Scenario:

- 1) A Dual signature PD is powered over 2 pairs
- 2) A PD_POWER_REQUEST is in progress
 - a. TempVar and MirroredPDRequestedPowerValue are in use
- 3) A transition to 4 pair power occurs
- 4) Suddenly the alt_x versions are in force
- 5) How does the state to state mapping occur when jumping from state machine to state machine?

PSE Power Control SM for SS PDs

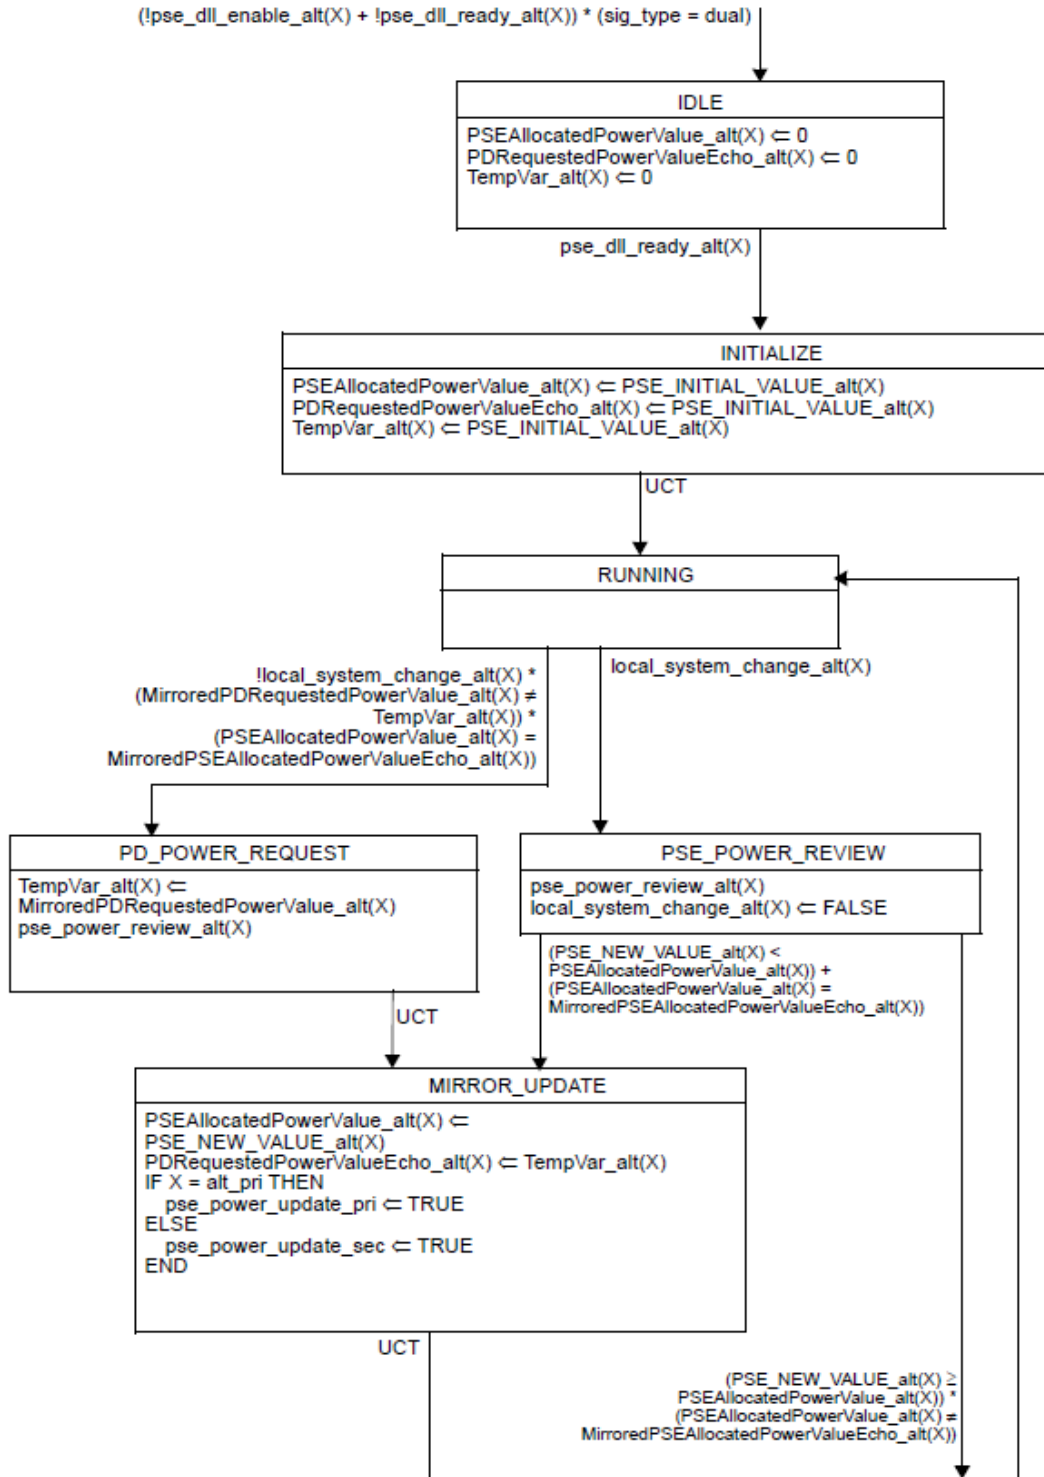
Instead is there a way to provision the SMs for DS PDs so state machine don't need to be laboriously glued together?

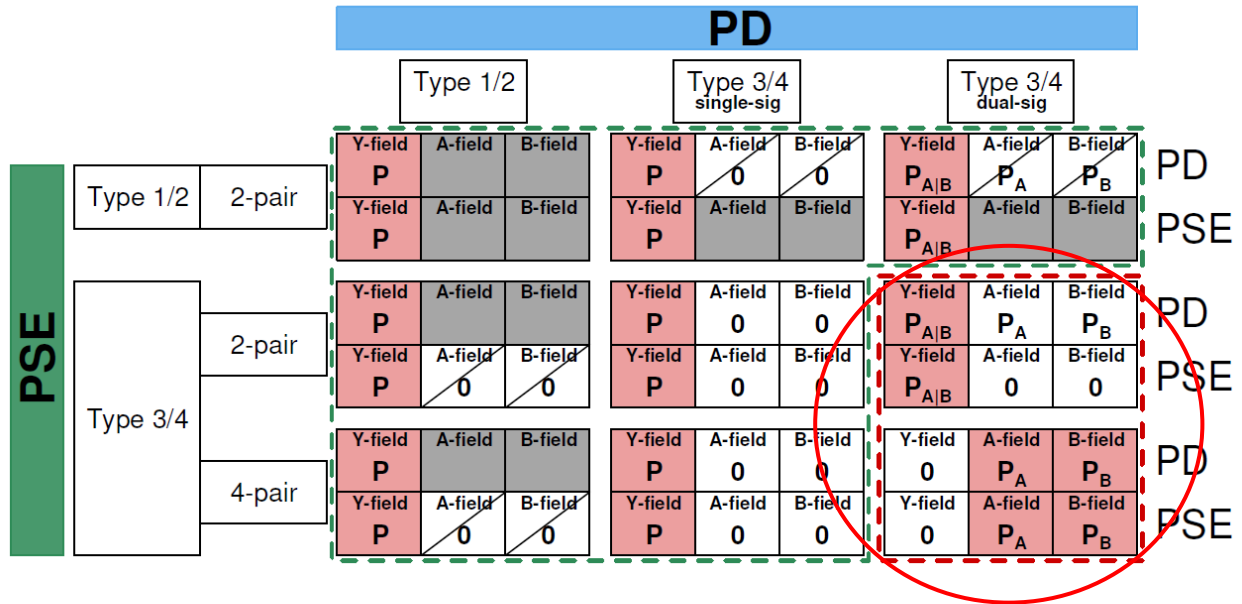
The root problem seems to lie in one particular set of cells in Lennart's proposal:

Can all states which assign power or mirrored power get the following additional logic:

If (X == A)
  If (pairsx == both)
    Y = 0
  else
    Y = A
Else
  If (pairsx == both)
    Y = 0
  else
    Y = B
